Stinson Lands

Conceptual Site Servicing & Stormwater Management Report

Reference: **Stinson Lands
Conceptual Site Servicing and Stormwater Management Report
Novatech File No.: 121153
City Planning File No.: D07-16-22-0026**

Figure 3 - Section A - Existing Conditions - Seismic Loading

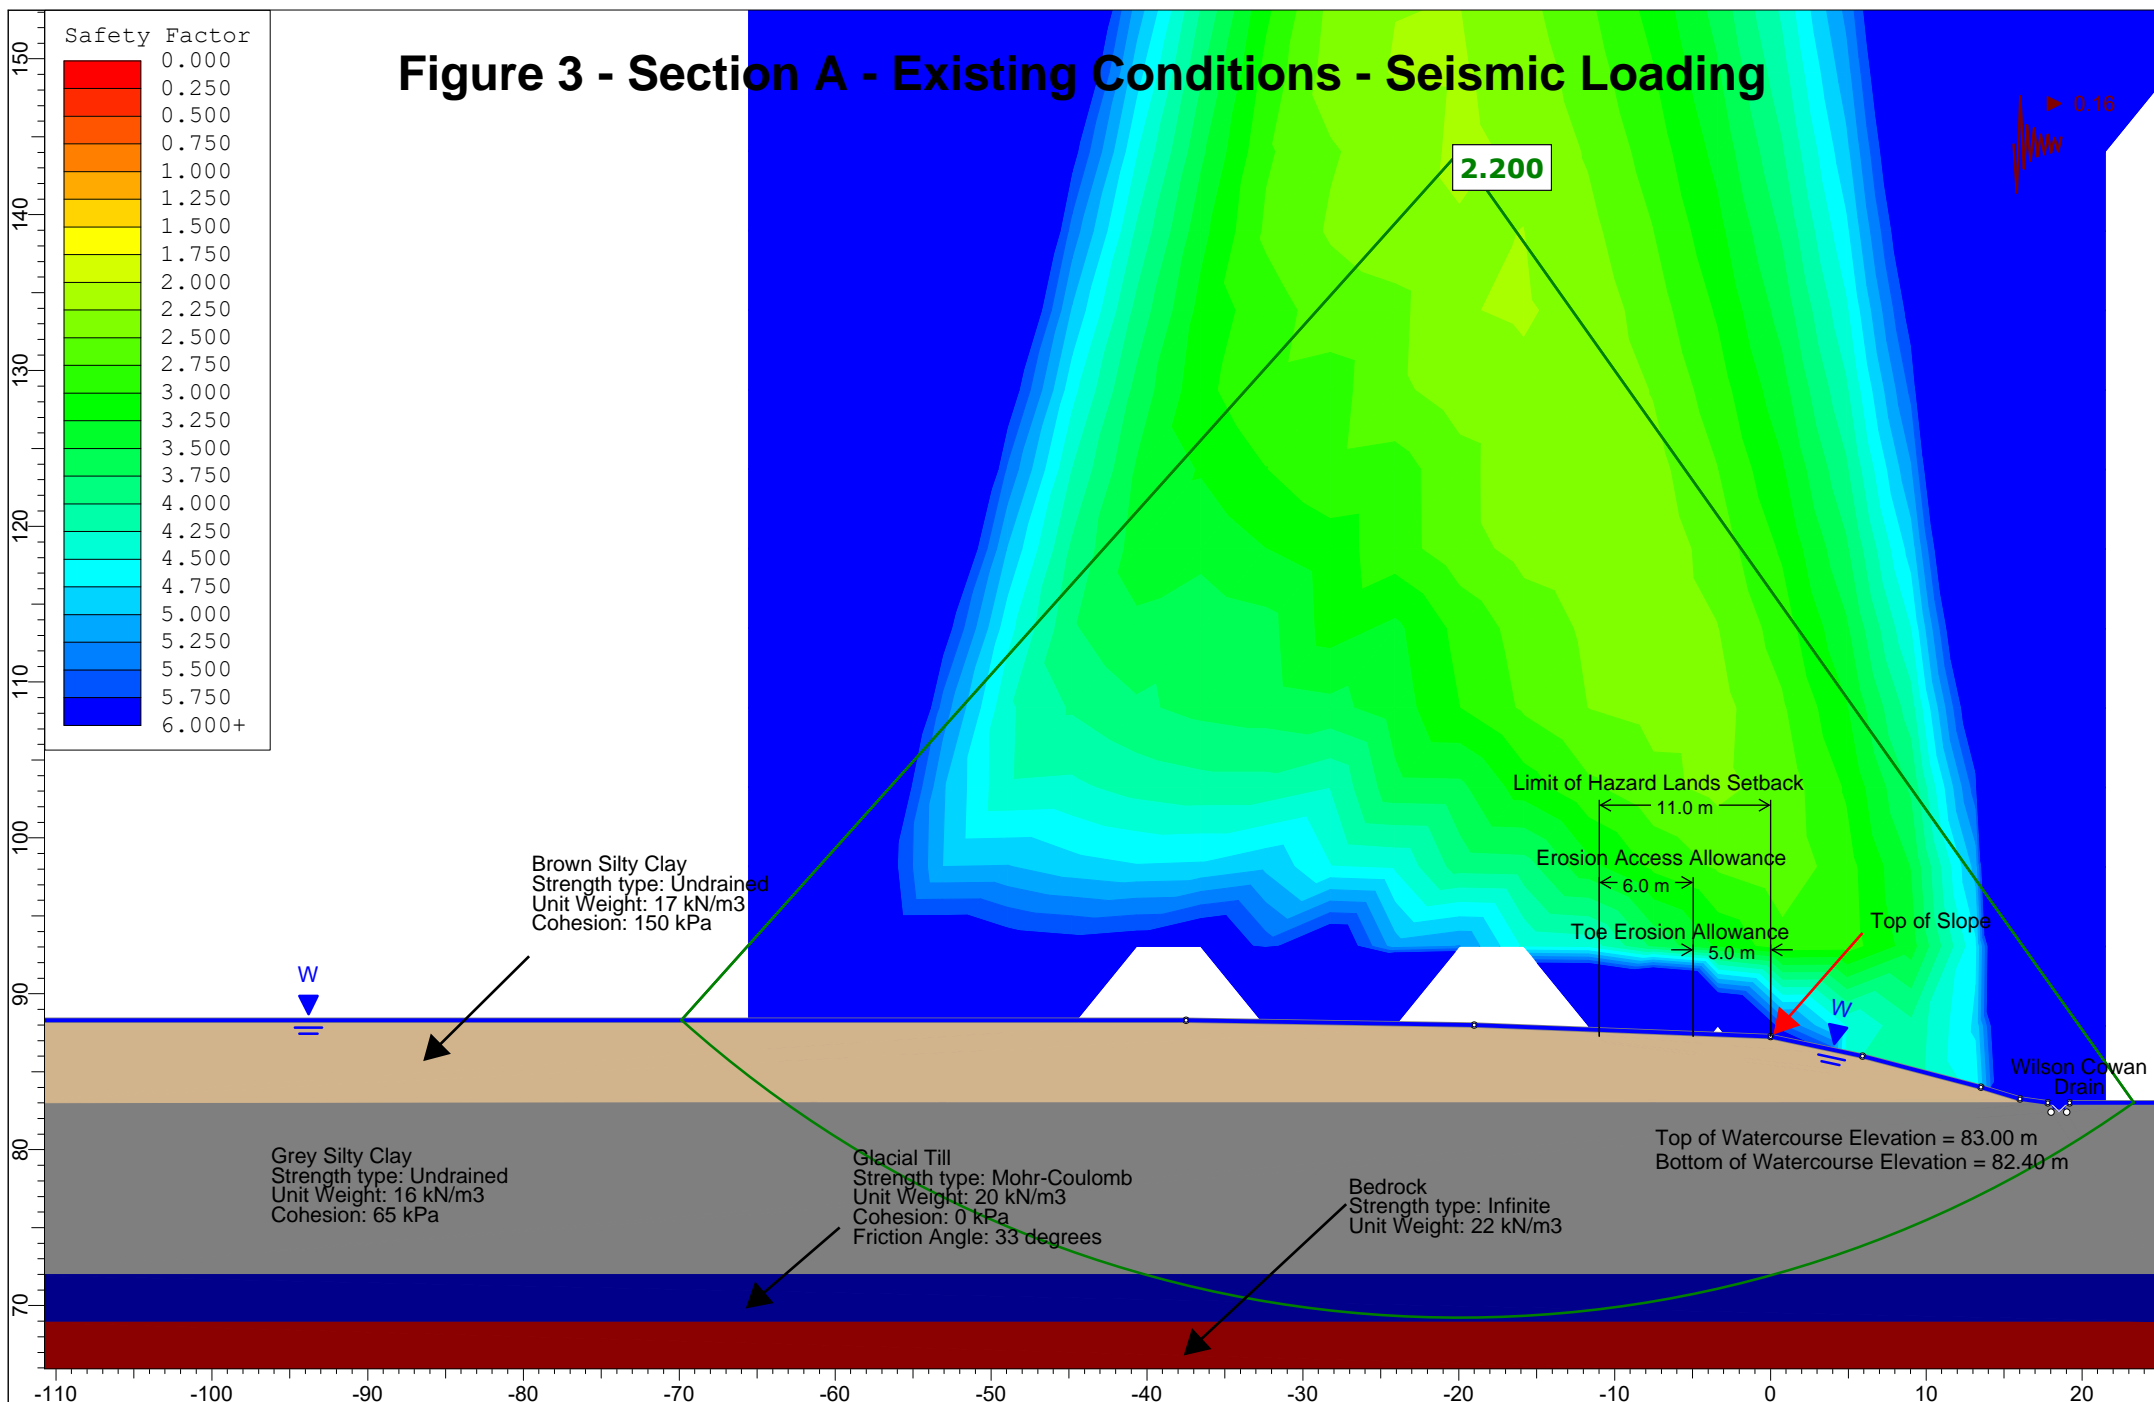
The soil annotations on Figure 3 appear to be floating.

(City01): Comment 2.43 *The soil annotations on Figure 3 appear to be floating.*

(City02): Outstanding: *Referencing Figure 3, page 52 of 114, three soil types are indicated to be included in the slip circle. Also note that grey silty clay soils are a significantly weaker soil and not considered homogenous. The City will need to see a couple of non-circular failure surface calculations.*

Noted. The annotations for soil layers in Figure 3 have been modified in the above-mentioned revised report.

Paterson's Previous Response: Noted. The annotations for soil layers in Figure 3 have been modified in the above-mentioned revised report.

This comment has been acknowledged. Multiple non-circular failure surfaces have been added to Figure 3. Please refer to the above-mentioned revised report.
